**CHEVRON PRODUCTS COMPANY'S COMMENTS ON:
PROPOSED STATE IMPLEMENTATION PLAN FOR THE 2015 OZONE NAAQS NORTHERN
WASATCH FRONT MODERATE NONATTAINMENT AREA**

SUBMITTED ELECTRONICALLY TO THE UTAH AIR QUALITY BOARD

JULY 17, 2023

Figure 15: Ozone Attributed to Domain-Wide Sources at Hawthorne as simulated 8-hour mean daily ozone concentrations along the Wasatch Front.

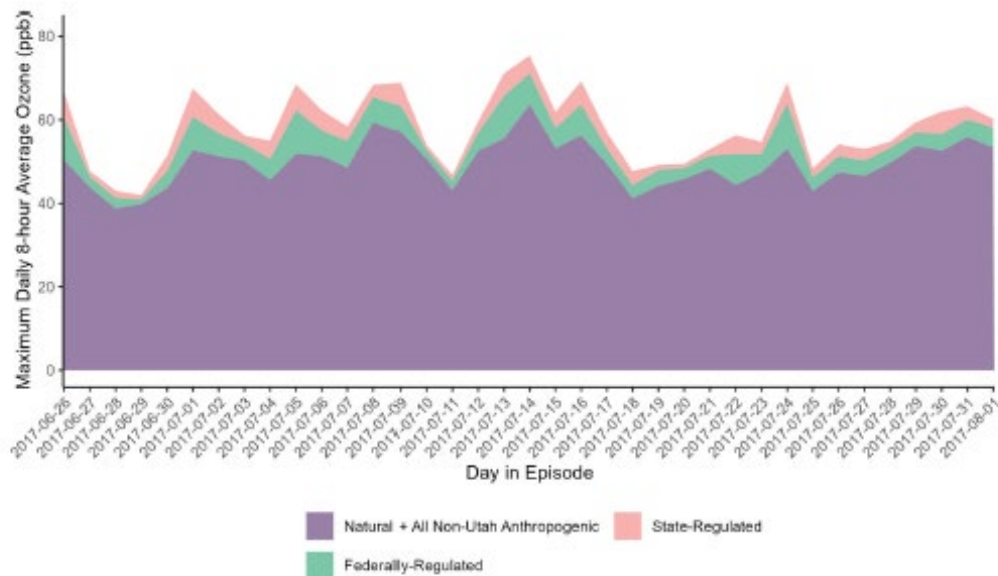
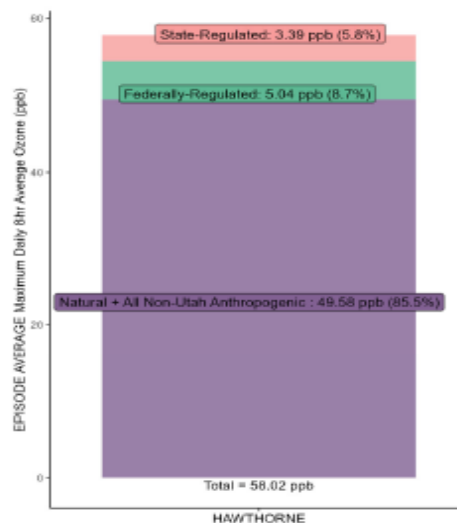
comprising the mean daily 8-hour concentrations” in the NWF.⁶¹ As Figures 15 and 16 in the Proposed SIP demonstrate, only 5.8% is attributable to anthropogenic sources that may be subject to regulation by the state of Utah:

Put practically, the 8.9 tpy NO_x reduction from the installation of ULNBs at the SLC Refinery is not only a small drop in the bucket of the 2017 NO_x inventory, but also insignificant in comparison to the scale of the ozone problem in Utah. It is not credible for UDAQ to claim that emission reductions from this specific control technology is necessary at any cost to achieve attainment as expeditiously as possible.

Figure 1. Ozone and 24-Hour PM_{2.5} Long Term Trends

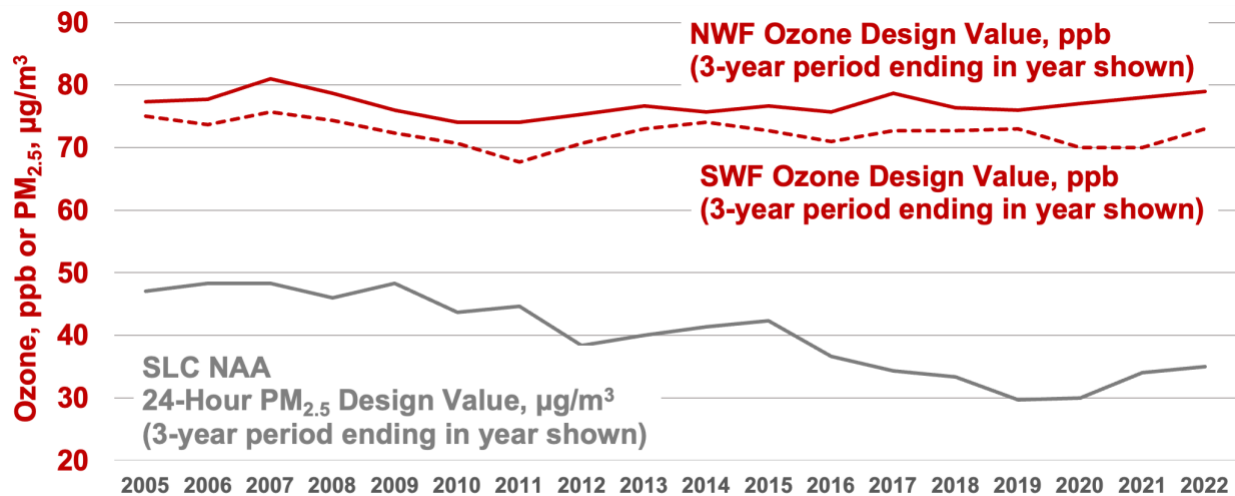
Despite the emission reductions, **Figure 1** shows that the ozone design value in the NWF has failed to improve even though the 24-hour PM_{2.5} design value, which includes VOC and NO_x as precursor emissions, shows a substantial long term improvement trend:

The proposed Moderate SIP makes no attempt to explain why the design value trend over the past twenty years would suddenly be responsive to new and very limited NO_x and VOC reductions, significantly smaller than reductions over the past several years, and provides little or no evidence in support of the anticipated response. It is not enough to simply trust the model.

Figure 1. Monitored VOC:NO_x ratios at Hawthorne using two different techniques using total non-methane hydrocarbons (TNMOC; top) and maximum incremental reactivity (MIR) weighted VOCs (bottom). Figure from Sghiatti and Daher (2022).

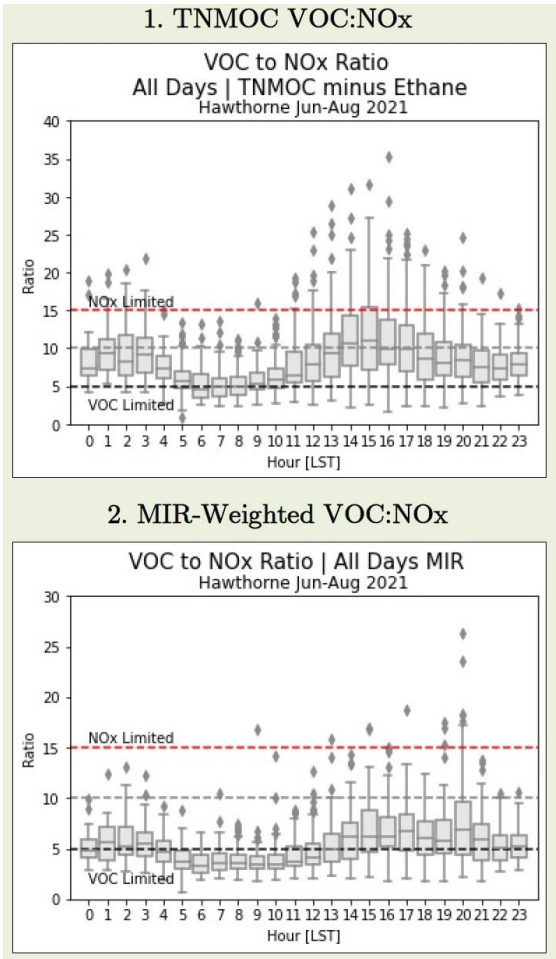
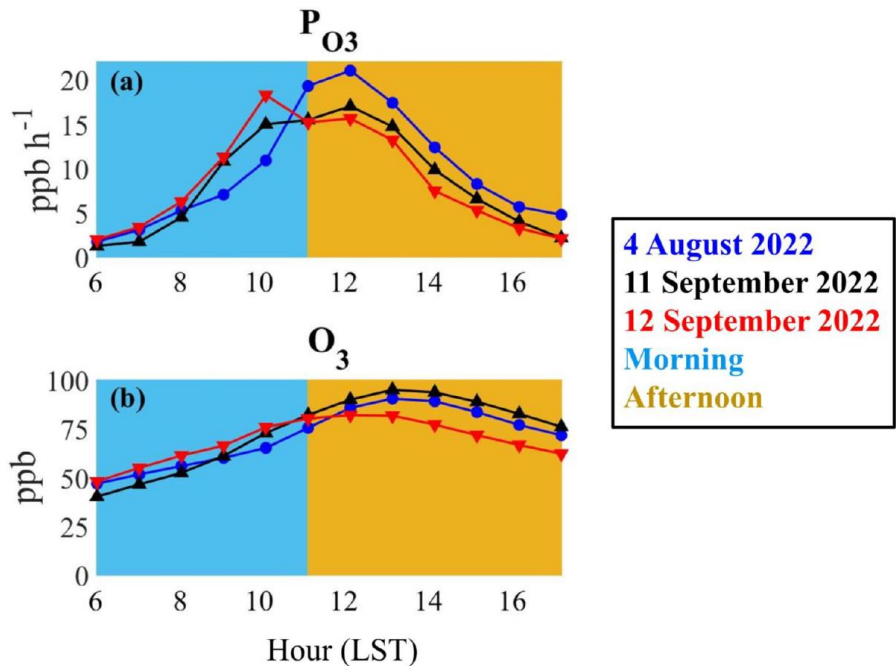
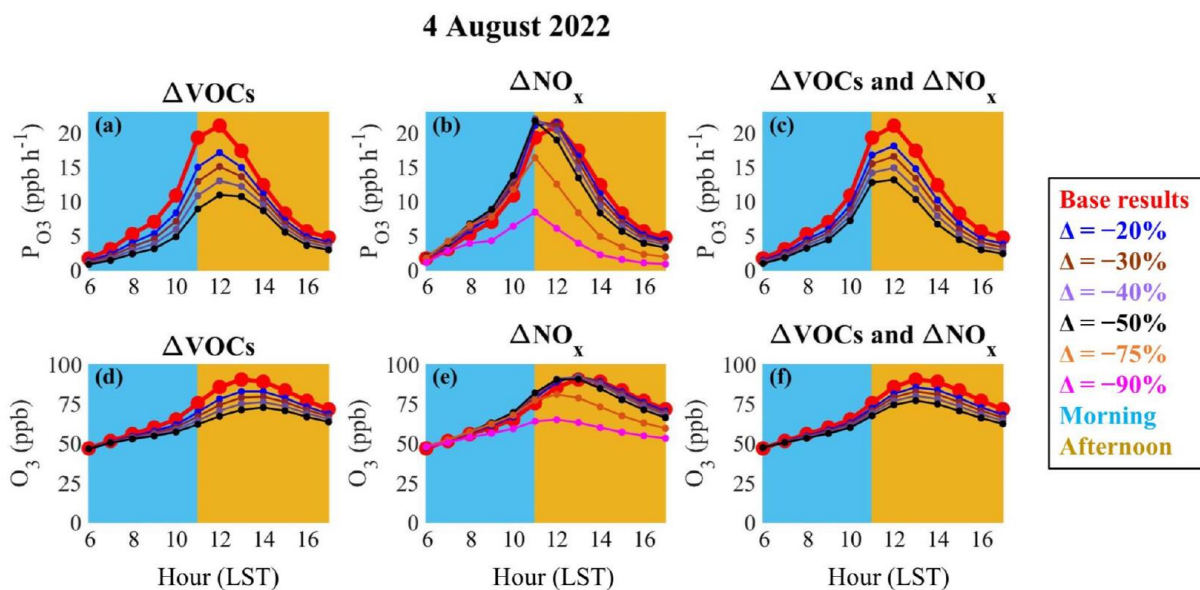
Under a Science for Solutions grant, Ninneman et al (2023) conducted photochemical box model simulations constrained by 2022 precursor and meteorological measurements at the Utah Technical Center during days influenced by wildfire smoke and on smoke-free days. The box model showed ozone production increasing during the morning hours and peaking around noon, after which ozone destruction processes dominated (Figure 2 below).

Therefore, VOC:NO_x ratio is best evaluated during the morning hours (e.g., 6 AM to 12 PM), when Figure 1 indicates a more VOC-limited regime regardless of reactivity weighting. Box model sensitivity tests in which VOC and NO_x precursor concentrations were systematically reduced separately and together showed strong responses to VOC and little response to NO_x until very deep NO_x reductions were applied (Figure 3 below) or reductions were applied collectively. Thus, results clearly show VOC-sensitive conditions at the Utah Technology Center, although that site measures some of the highest NO_x in the area and so results in Figure 3 are not surprising.

In summary, recent ozone and precursor analyses at two different monitoring sites indicate a stronger tendency toward VOC-limited photochemistry during hours of increasing and maximum ozone production, while CAMx shows a stronger tendency toward NOx-limited photochemistry. There are several possible reasons for this, as both techniques are associated with uncertainties: (1) since the model is not constrained by measured values (as box modeling is), error propagation stemming from uncertainties in emissions (values, time/space allocation) or meteorological inputs (chemical kinetics, vertical mixing, transport patterns) may cause an improper characterization of chemical sensitivity; (2) point measurements at monitoring sites sense local conditions but cannot provide information on how ozone is formed in other areas of the NWF NAA that are transported into the local monitored area. Both issues are likely at play to various extents, however, the documented CAMx performance issues throughout the modeling period weaken conclusions drawn from the modeling about NOx-sensitive conditions and strengthen conclusions about VOC-sensitive conditions drawn from the monitoring studies.

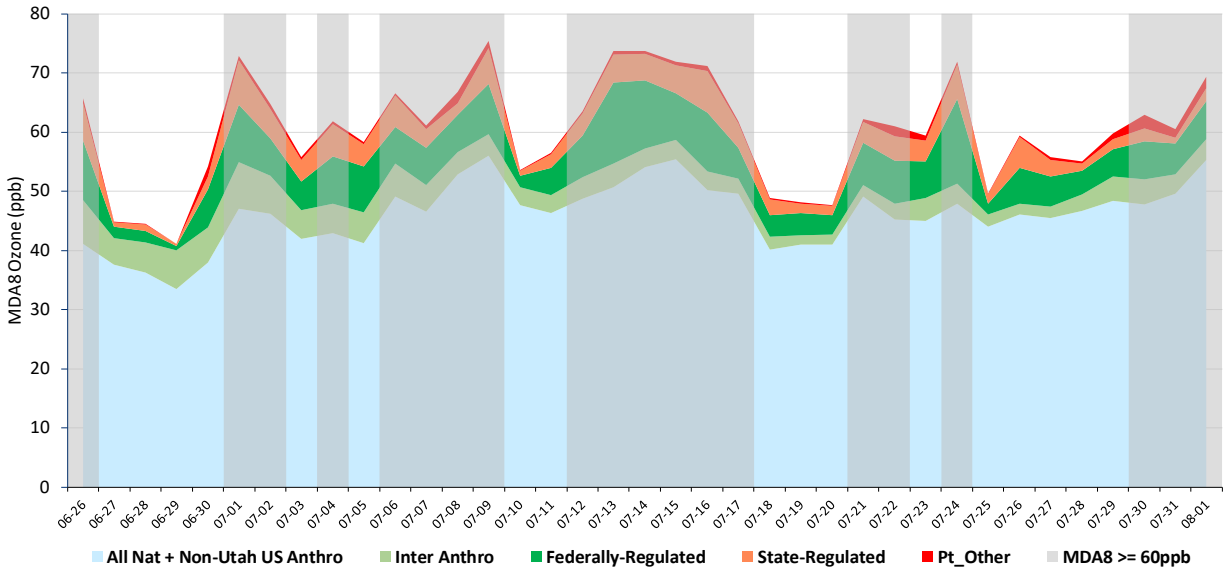
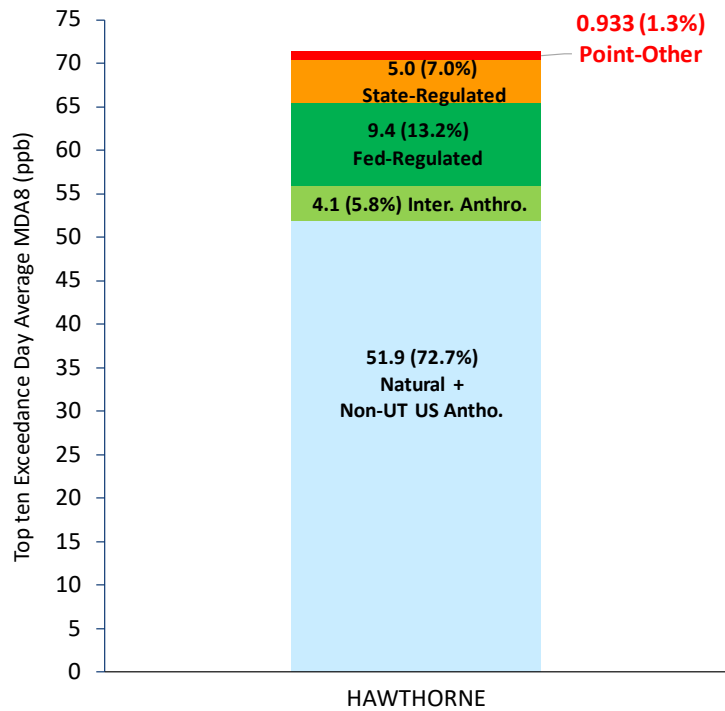
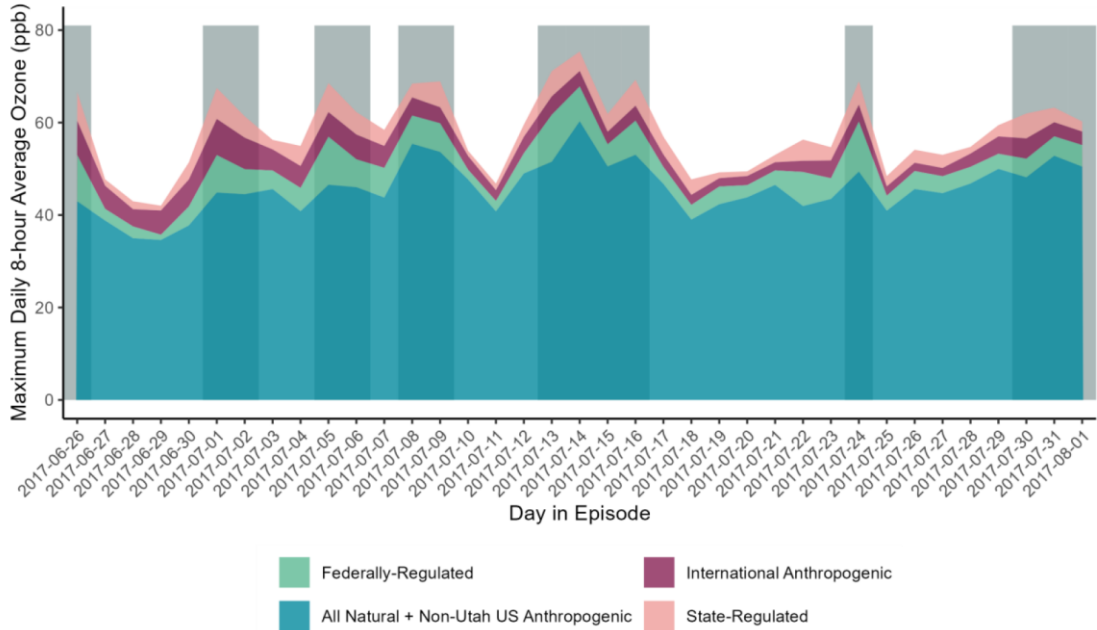
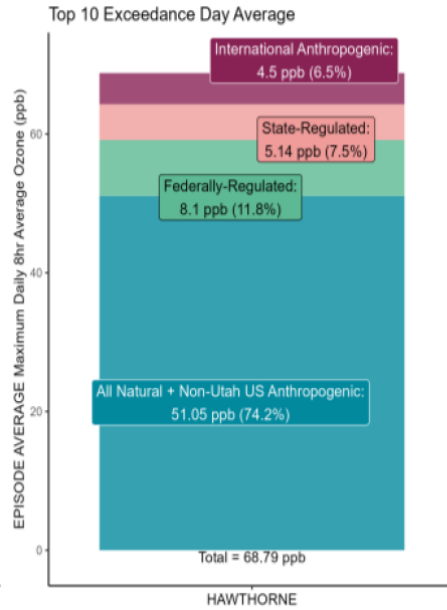
We received UDAQ’s model output files via disk transfer and processed raw hourly OSAT tracer concentrations to MDA8 ozone in local time. Figure 4(a) shows resulting time series of attribution for five aggregate source categories at Hawthorne, while Figure 4(b) shows the average over the top 10 highest simulated ozone days. Figure 5 is a copy of Figure 17, page 132 from the main SIP document. We extracted data from CAMx “receptor files”, which report source apportionment results at pre-defined receptor coordinates defined by UDAQ. However, we could not replicate UDAQ’s source apportionment results; while exhibiting similar patterns, our results tend to be higher during peak periods and the distribution of high days differ.

We conducted substantial quality assurance checks of our approach at each processing step and tested numerous possible causes. This included confirming that we could achieve identical results by extracting data from raw gridded data (rather than receptor files) and confirming that total ozone simulated by the core model at Hawthorne matched the sum of all tracers shown in Figure 4. We also extensively interacted with UDAQ staff to find possible reasons of discrepancies at each step of processing but could not identify a specific cause. Based on our substantial checks, we are certain that our results are correct.

Figure 6. Average of Ramboll’s processing of MDA8 ozone contribution at Hawthorne over the top 10 days shown in Figure 4(a) from 6 aggregated “other point source” tracers. Contributions are split by whether ozone was generated by NOx (O3N) or VOC (O3V) sensitivity photochemistry.

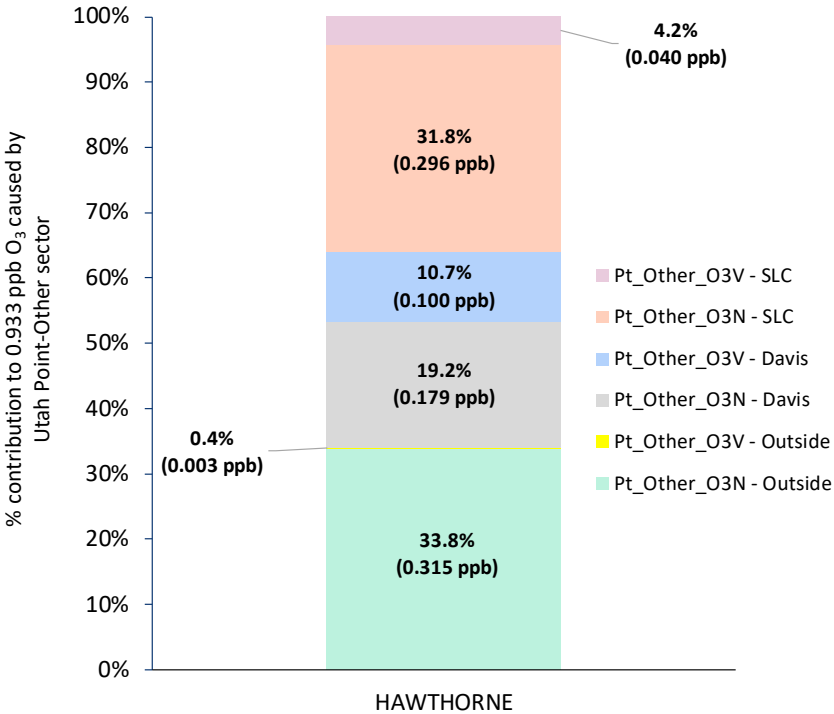
According to our results, the “other point source” category that contains refineries contributes a total of 0.9 ppb over the top 10 simulated MDA8 ozone days. Figure 6 shows a breakout of the 0.9 ppb contribution from “other point sources” by NOx (O3N) and VOC (O3V) sensitive ozone production, and from Salt Lake County, Davis County, and other areas outside the two counties. Point sources in Salt Lake County contribute 0.30 ppb (32%) and 0.04 ppb (4%) from NOx and VOC sensitive chemistry, respectively. Point sources in Davis County contribute 0.18 ppb (19%) and 0.10 ppb (11%) from NOx and VOC sensitive chemistry, respectively. For both counties, results indicate more NOx-sensitive ozone formation from point sources. All other point sources located throughout the remainder of the 4/1.33 km modeling domains contribute 0.32 ppb (34%) and <0.01 ppb (0.4%) from NOx and VOC sensitive chemistry, respectively. The stronger NOx-sensitive response from the outside point sources makes sense as they are mostly removed from the central urbanized area of the NAA, and thus ozone formation occurs in more NOx-lean and relatively biogenic VOC-rich suburban and rural areas.

We estimated the ozone impacts from simulated refinery control measures in 2023 at Hawthorne by multiplying contributions from Figure 6 by the relative emission reductions shown in Table 1. Results are shown in Table 2. The total simulated MDA8 ozone reduction from refinery measures averaged over the highest modeled ozone days is 0.02 ppb. Conceivably this impact would be smaller if the model simulated a VOC-sensitive environment rather than NOx-sensitive, as indicated by monitoring studies.

Figure 1. Monitored VOC:NO_x ratios at Hawthorne using two different techniques using total non-methane hydrocarbons (TNMOC; top) and maximum incremental reactivity (MIR) weighted VOCs (bottom). Figure from Sghiatti and Daher (2022).

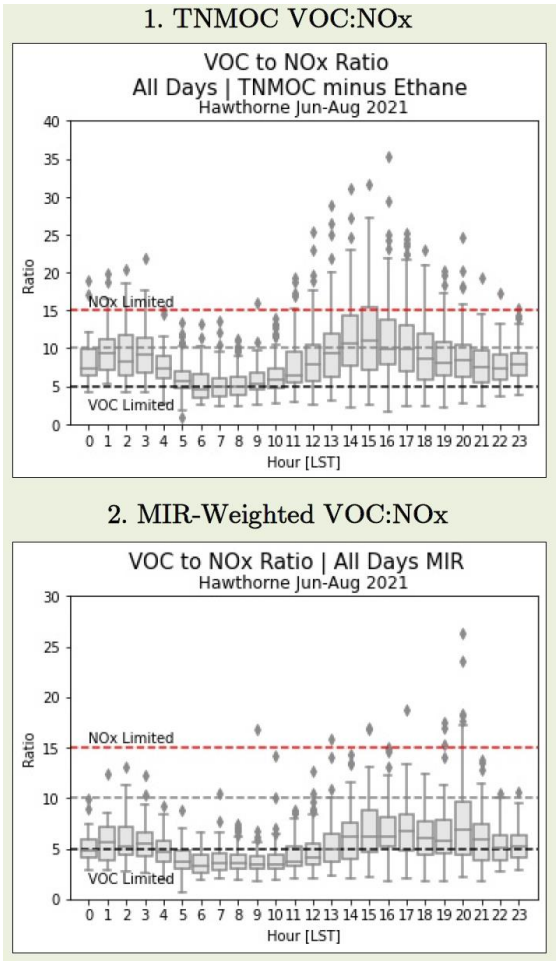
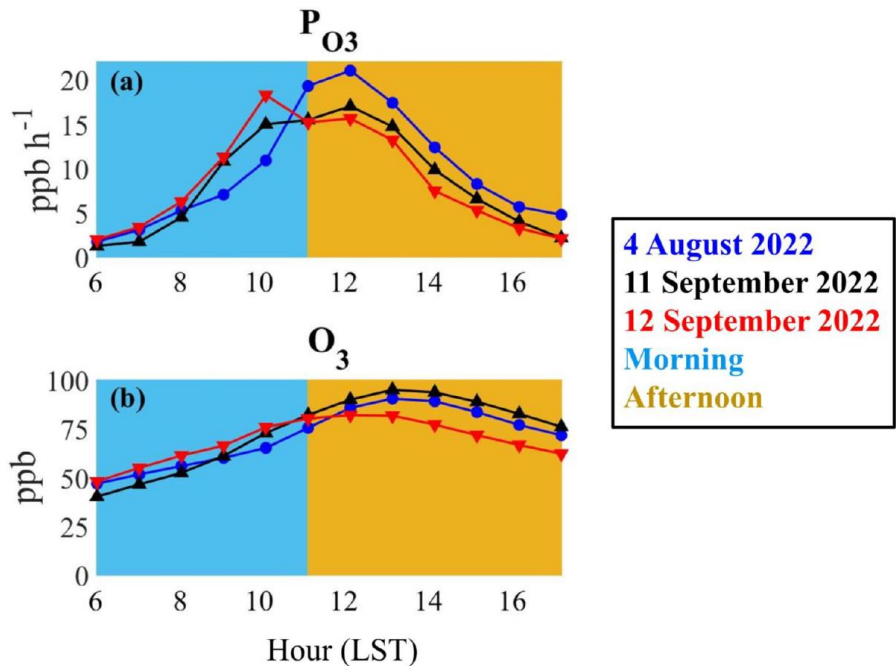
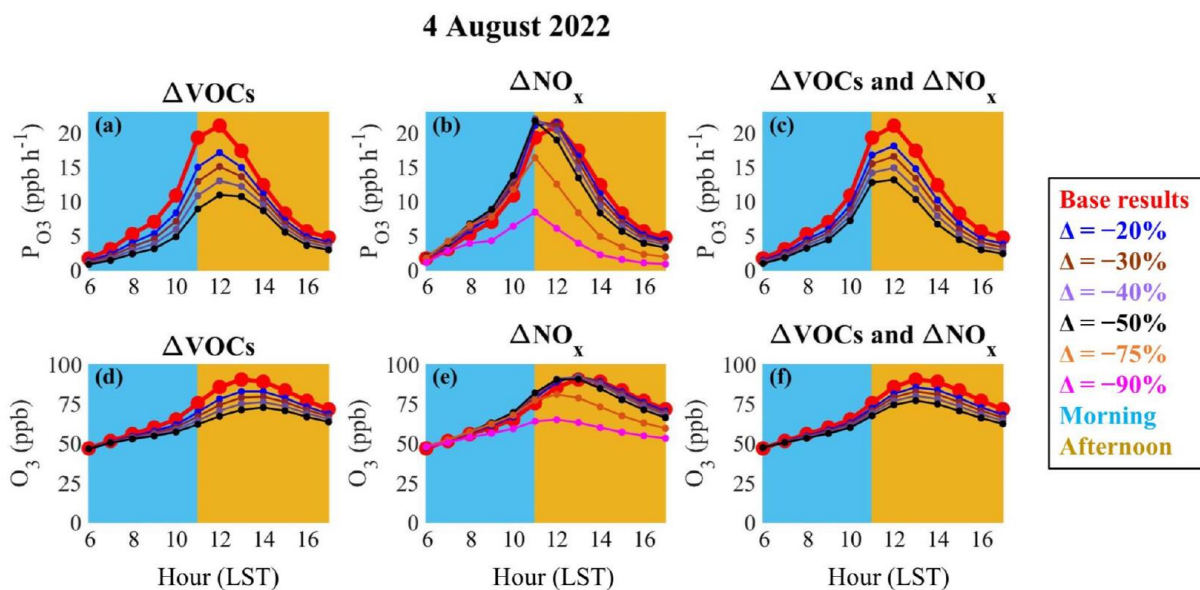
Under a Science for Solutions grant, Ninneman et al (2023) conducted photochemical box model simulations constrained by 2022 precursor and meteorological measurements at the Utah Technical Center during days influenced by wildfire smoke and on smoke-free days. The box model showed ozone production increasing during the morning hours and peaking around noon, after which ozone destruction processes dominated (Figure 2 below).

Therefore, VOC:NO_x ratio is best evaluated during the morning hours (e.g., 6 AM to 12 PM), when Figure 1 indicates a more VOC-limited regime regardless of reactivity weighting. Box model sensitivity tests in which VOC and NO_x precursor concentrations were systematically reduced separately and together showed strong responses to VOC and little response to NO_x until very deep NO_x reductions were applied (Figure 3 below) or reductions were applied collectively. Thus, results clearly show VOC-sensitive conditions at the Utah Technology Center, although that site measures some of the highest NO_x in the area and so results in Figure 3 are not surprising.

In summary, recent ozone and precursor analyses at two different monitoring sites indicate a stronger tendency toward VOC-limited photochemistry during hours of increasing and maximum ozone production, while CAMx shows a stronger tendency toward NOx-limited photochemistry. There are several possible reasons for this, as both techniques are associated with uncertainties: (1) since the model is not constrained by measured values (as box modeling is), error propagation stemming from uncertainties in emissions (values, time/space allocation) or meteorological inputs (chemical kinetics, vertical mixing, transport patterns) may cause an improper characterization of chemical sensitivity; (2) point measurements at monitoring sites sense local conditions but cannot provide information on how ozone is formed in other areas of the NWF NAA that are transported into the local monitored area. Both issues are likely at play to various extents, however, the documented CAMx performance issues throughout the modeling period weaken conclusions drawn from the modeling about NOx-sensitive conditions and strengthen conclusions about VOC-sensitive conditions drawn from the monitoring studies.
